Subject: Docket No. 50-482: Response to Supplemental Information Request for License Amendment Request Deviation from Fire Protection Requirements – Reactor Coolant System Subcooling During Alternative Shutdown (TAC NO. ME4757)

**Response to Supplemental Information Request for License Amendment Request  
Deviation from Fire Protection Requirements – Reactor Coolant System Subcooling  
During Alternative Shutdown**

**Results for Scenarios 1, 1A , 2, and 2A With PORV Open Greater Than 3 Minutes**

**Figure 1-7 Upper core void fraction**

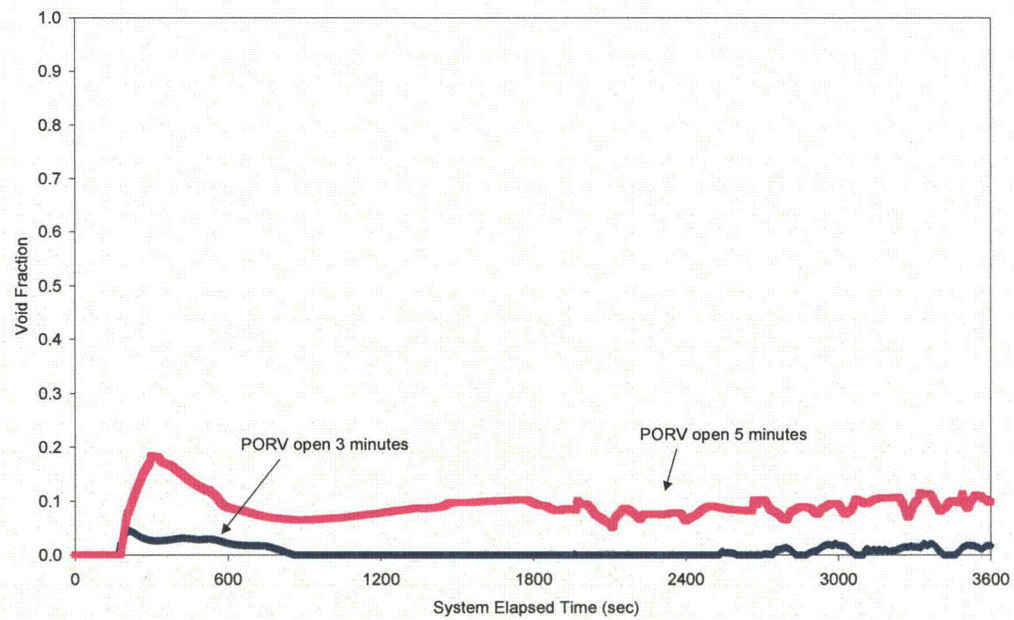
1. *Please describe what happens if the PORVs are not closed in 3 minutes. Since the current licensing basis may allow five minutes, without having considered loss of subcooling, if NRC staff approves this amendment, staff may need to unapprove the five minutes in their program.*

In the Scenario 1 and 1A cases with the PORV open for 5 minutes, the peak upper core void fraction is less than 19% and occurs approximately 5 minutes after the PORV opens. The maximum upper head void fraction is less than 60%. The core mass flowrates are slightly higher with a higher pressurizer level and lower pressurizer pressure than the 3 minute cases. The continued positive core mass flowrates and the core exit temperatures below 712°F demonstrate that unrestorable conditions will not be reached.
